**TITLE:** Draft Charleston Corridor Feasibility Study and Charleston East Transportation Improvements/Right-of-Way Impacts

The purpose of this Study Session is for City Council to provide direction on Google's draft Charleston Corridor Feasibility Study and transportation improvements surrounding the Charleston East development site.

NBPP Concept Charleston Road

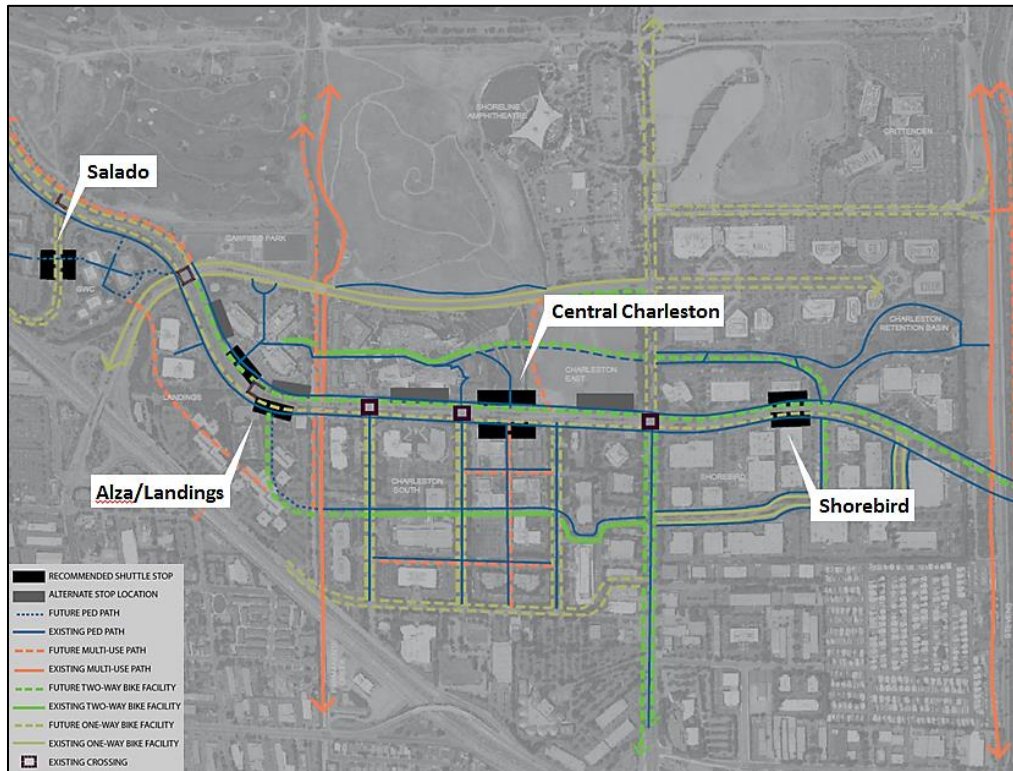
A feasibility study to refine the concept of the Charleston transportation corridor, evaluate tree and right-of-way impacts, and other early design activities is funded as a City capital improvement project, though Public Works staff has not yet begun the project. In July 2016, Google provided the City with a draft Charleston Corridor Feasibility Study (Study) as part of the design of the Charleston East development. The draft Study recommends deviations from the NBPP Charleston Road concept by consolidating transit stops and allowing bus pullouts instead of distributed bus stops along the corridor. The pullouts could be incorporated with an interim NBPP improvement phase (the consolidated stops only) where two vehicle travel lanes would remain, and with the full NBPP improvements, including converting one of the travel lanes to a dedicated transit lane. Staff supports this concept, but because it deviates from the NBPP and has right-of-way impacts, staff is seeking Council direction on the revised concept.

Bus Stop Pullout in Front of Charleston Park

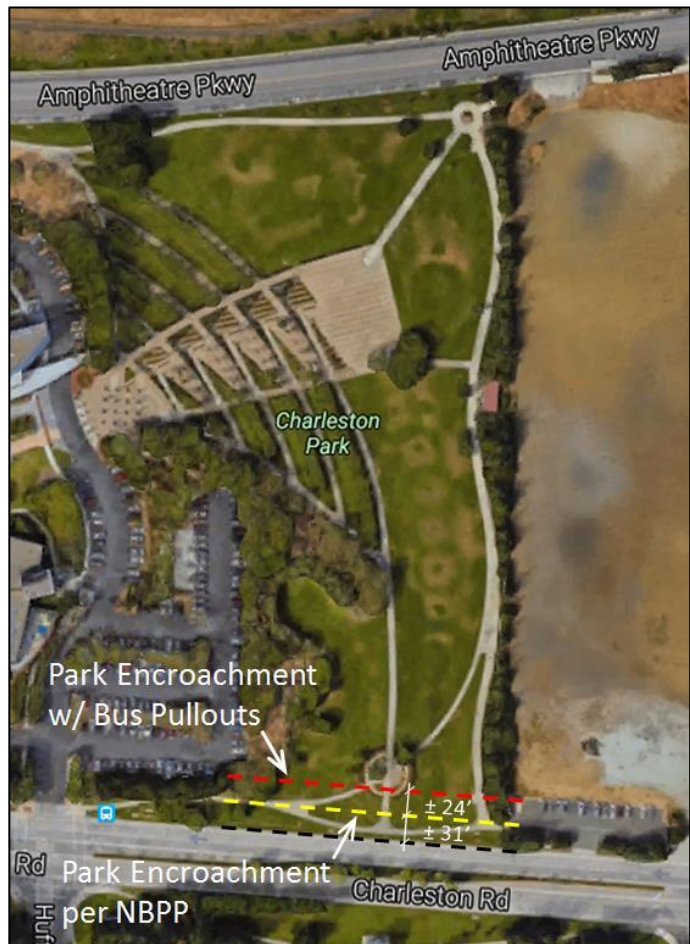
A disadvantage of this location is the encroachment into the park by approximately 24' compared with the concept approved in the NBPP. Under the NBPP concept, the construction of landscape buffers (10'), a two-way cycle track (13'), and a sidewalk (8'), would encroach into the park approximately 31' along the entire park frontage. With the recommended pullout space, an

additional 24' would be needed for the pullout and a transit stop. Due to the length of street frontage needed to accommodate five buses, the transit stop would take up a majority of the block between Huff Avenue and Joaquin Road. The park's entire Charleston Road frontage and a portion of the frontages along both the Googleplex site and Charleston East site would be affected. The transit stop may be shifted toward one of the two sites, but the transit stop's size and close proximity to the two intersections limit shifting the transit stop to avoid impacting a majority of the park's frontage.

Question 2: Does the City Council support a bus pullout location at the Charleston Park site?

Staff supports the Charleston Park location due to the high volume of transit riders needed to implement the aggressive mode shift as identified in the NBPP, requiring well-placed and proper transit stops. Alternative locations to the park include placing the pullout adjacent to the Googleplex or the Charleston East development site. Both locations have existing trees along the Charleston Road street frontage and rise in elevation from the street. Should Council direct, further evaluation of the specific impacts of the alternative locations would need to be studied.

NBPP Concept of an Access Street

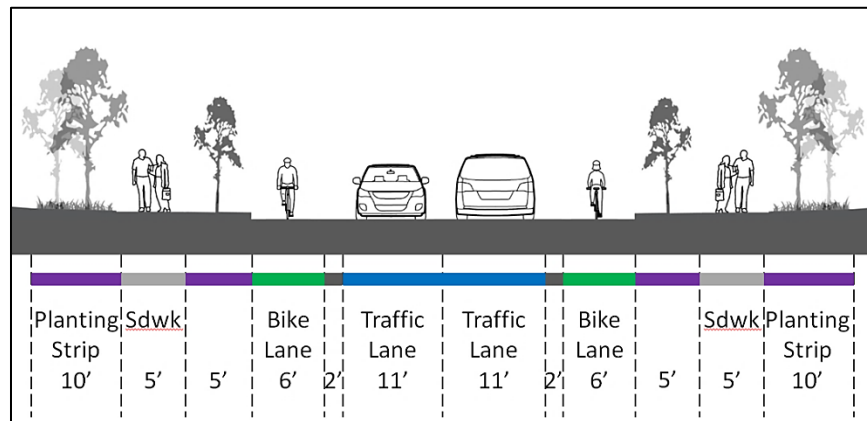
new access street. To better accommodate bicycles, Google is proposing to provide a two-way cycle track on the west side of Joaquin Road only, in lieu of on-street bicycle lanes as shown in the NBPP cross section (see Figure 7). Both Charleston Road and Amphitheatre Parkway require the installation of two-way cycle tracks adjacent to the Charleston East development site. Providing a two-way cycle track on the Joaquin Road extension is a higher-quality bicycle facility and consistent with the other cycle-track improvements and connections proposed adjacent to Joaquin Road. The right-of-way needs are similar in both cases. Staff concurs with the cycle track proposal for Joaquin Road.

Question 4: Does the City Council support a two-way cycle track on the west side of the Joaquin Road extension?

NBPP Concept of a Gateway Boulevard

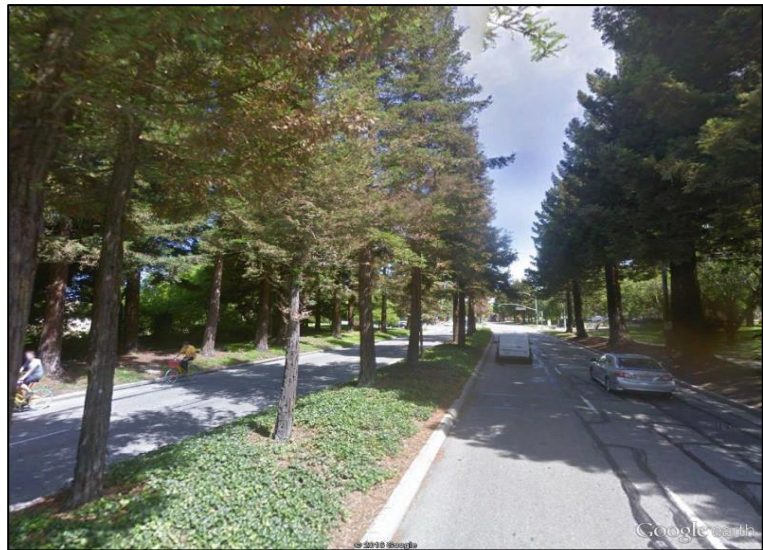
would necessitate the removal of all of the redwood trees along the entire western side of the Shoreline Boulevard frontage between Amphitheatre Parkway and Charleston Road (approximately 100 trees). Staff is requesting Council direction on whether this is an acceptable approach and has also prepared two alternatives for Council's consideration in order to keep the allée as previously requested.

Question 5: Does Council support the installation of the NBPP transportation improvements along Shoreline Boulevard or is a modified improvement configuration preferred? If an alternate is preferred, does Council support Option 1 or Option 2?

Staff recommends Option 1 because it allows for the preservation of a significant number of trees and the Shoreline Boulevard allée while also allowing for the consistent implementation of bike and pedestrian improvements along the entire Shoreline Boulevard corridor as envisioned in the NBPP.

Option 1 – Site Photo

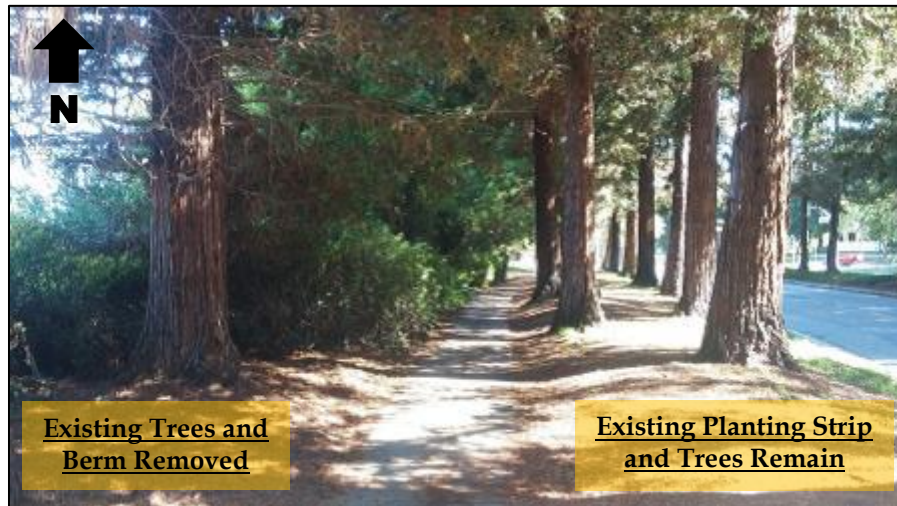
The first alternative would be to keep all the redwood trees in the existing planting strip, between the existing sidewalk and the street, and install a 13' bidirectional cycle track and 8' sidewalk to the west of this existing planting strip. The existing park strip varies in width (approximately 5' to 10') and would be greater than the required 5' planting strip required in the NBPP. The redwood trees in the street planting strip are in fair to good health.

This option would necessitate the removal of all the trees to the west of the existing sidewalk to allow the installation of the bike and pedestrian improvements (approximately 45 trees). This option would maintain the allée along this section of Shoreline Boulevard because there would be a continuous row of redwoods maintained on both sides of the street and in the center island median. This option would also implement the bike and pedestrian improvements as envisioned in the NBPP with little deviation.
